DART SERVICE INSTRUCTION

TO AMEND INSTALLATION INSTRUCTIONS IIN-D412-698 REV. E & INSTRUCTIONS FOR
CONTINUED AIRWORTHINESS ICA-D412-698 REV. 5

A	NEW ISSUE	MB	12.11.21
REV.	DESCRIPTION	BY	DATE
DESIGN		DART AEROSPACE LTD	
DRAWN		HAWKESBURY, ONTARIO, CANADA	
CHECKED		DRAWING NO.	REV. A
MFG. APPR.	N/A	DSI 9635	SHEET 1 OF 5
APPROVED		TITLE	SCALE
DE APPR.		ROLLER BRACKET CHANGE KIT	NTS
DATE	12.11.21	COPYRIGHT © 2012 BY DART AEROSPACE LTD THIS DOCUMENT IS PRIVATE AND CONFIDENTIAL AND IS SUPPLIED ON THE EXPRESS CONDITION THAT IT IS NOT TO BE USED FOR ANY PURPOSE OR COPIED OR COMMUNICATED TO ANY OTHER PERSON WITHOUT WRITTEN PERMISSION FROM DART AEROSPACE LTD.

FIGURE 1 – INSTALLATION OVERVIEW

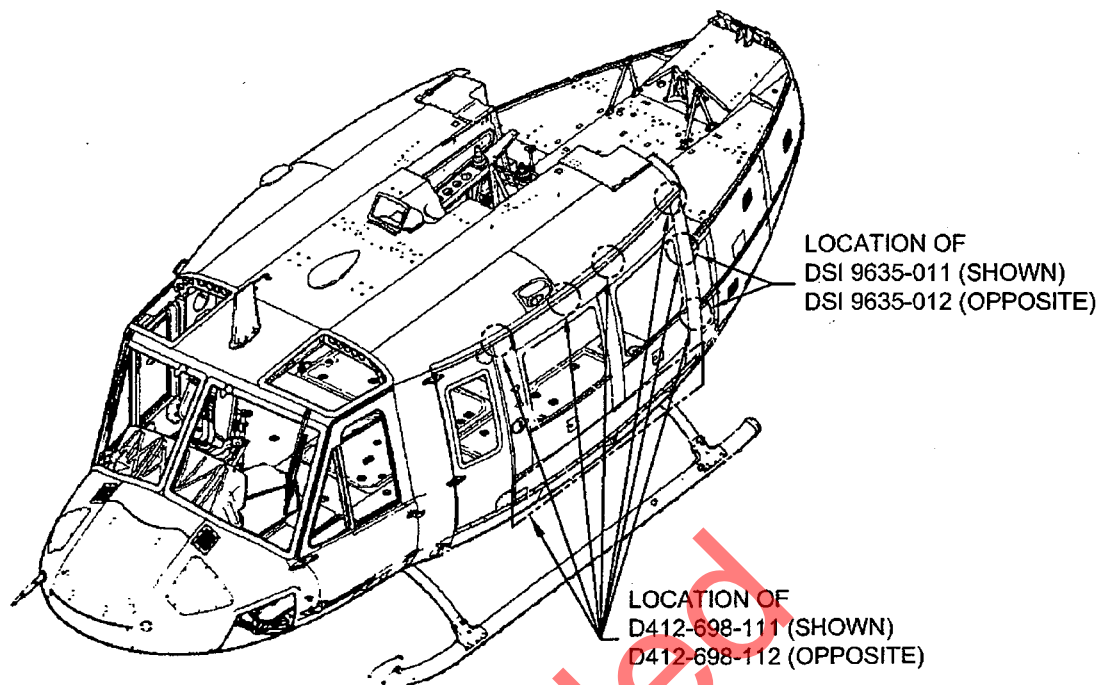
- 3.1 Remove LH and/or RH sliding doors (ref P/N 205-031-669-15/-16) from the aircraft per the Aircraft Maintenance Manual.
- 3.2 Remove 205-031-436-001 and replace with D3121-141 Bracket (3 places). Reuse existing hardware and shims if determined to be airworthy. Alternatively, if using D412-698-021 Replacement Shim Kit, install D3238-1 & D3238-11 as required. **Note** that the D3121-141 brackets contain one additional middle slot not used for this installation (see Figure 6 of IIN-D412-698 or Figure 52-8 of ICA-D412-698).

- 3.3 Remove 205-031-435-001/002 and replace with D3121-143 Bracket for left hand doors and D3121-144 Bracket for right hand doors. Reuse existing mounting hardware and shims if determined to be airworthy. Alternatively, if using D412-698-021 Replacement Shim Kit, install D3238-3 & D3238-13 as required. **Note** that the D3121-143/-144 brackets contain one additional middle slot not used for this installation (see Figure 6 of IIN-D412-698 or Figure 52-8 of ICA-D412-698).

- 3.4 Remove 205-031-433-1 Roller Support (LH) and 205-031-433-2 Roller Support (RH) and replace with D4737-043 on left hand doors and D4737-044 on right hand doors. Reuse existing mounting hardware and shims if determined to be airworthy. Alternatively, if using D412-698-021 Replacement Shim Kit, install D3238-5 & D3238-15 as required.
NOTE: The upper aft door track on early model aircraft may not have been modified to accept the extra roller on the D4737-043/-044 Brackets. If this track has not been modified, it should be modified in accordance with BHT TB 205-99-105 at this time.

FIGURE 2 - MODIFIED SLIDING DOOR
(D412-698-111 SHOWN, D412-698-112 OPPOSITE)

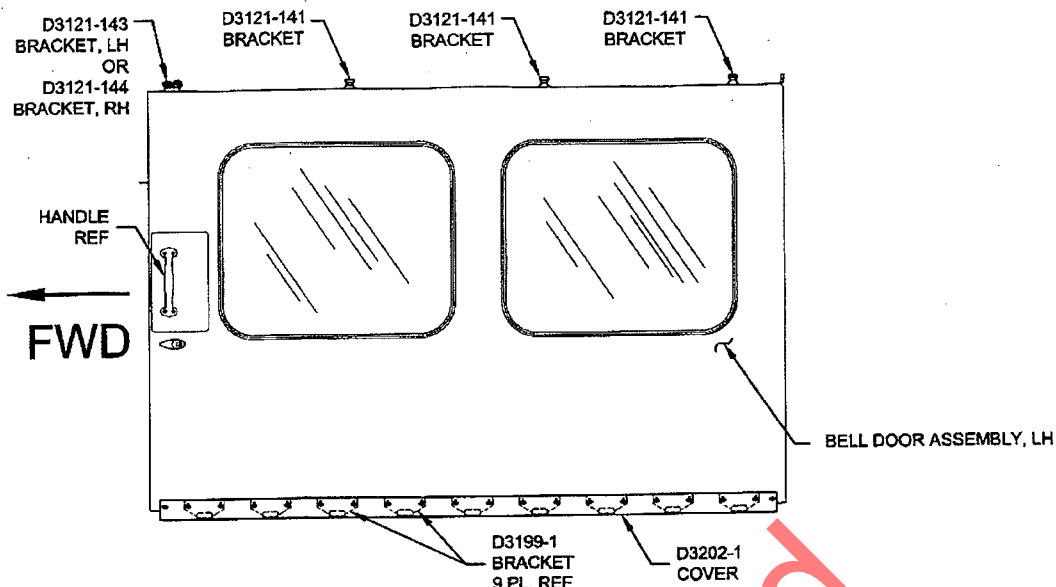
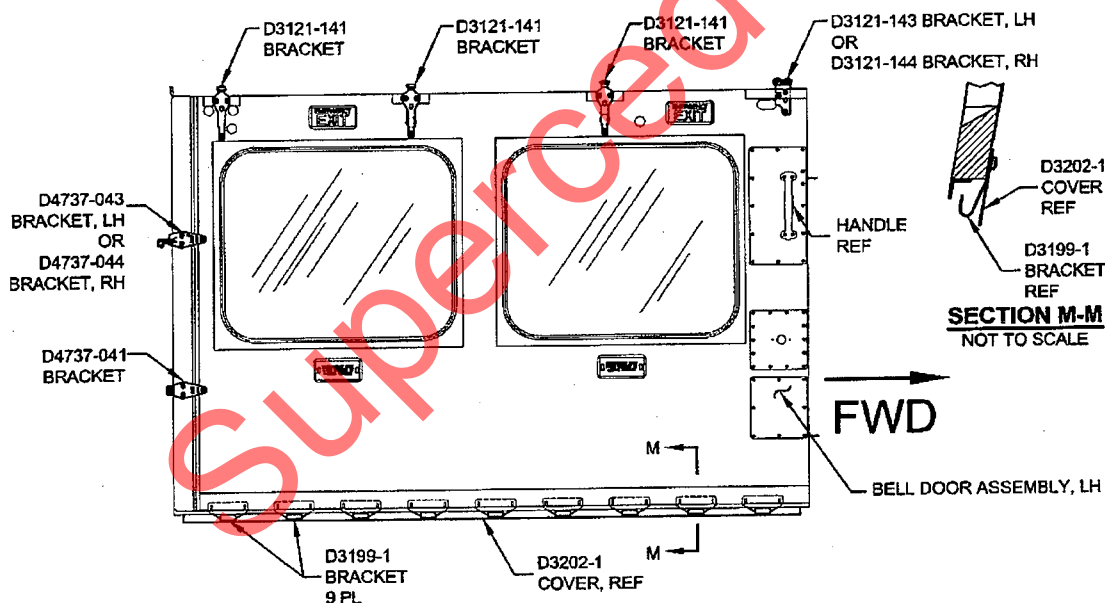
- 3.6 Remove 205-032-669-125 Track (LH) and/or 205-032-669-126 Track (RH) as applicable. Install D3199-1 Brackets and D3202-1 Cover as shown in Figure 2a using existing mounting hardware if determined to be airworthy.
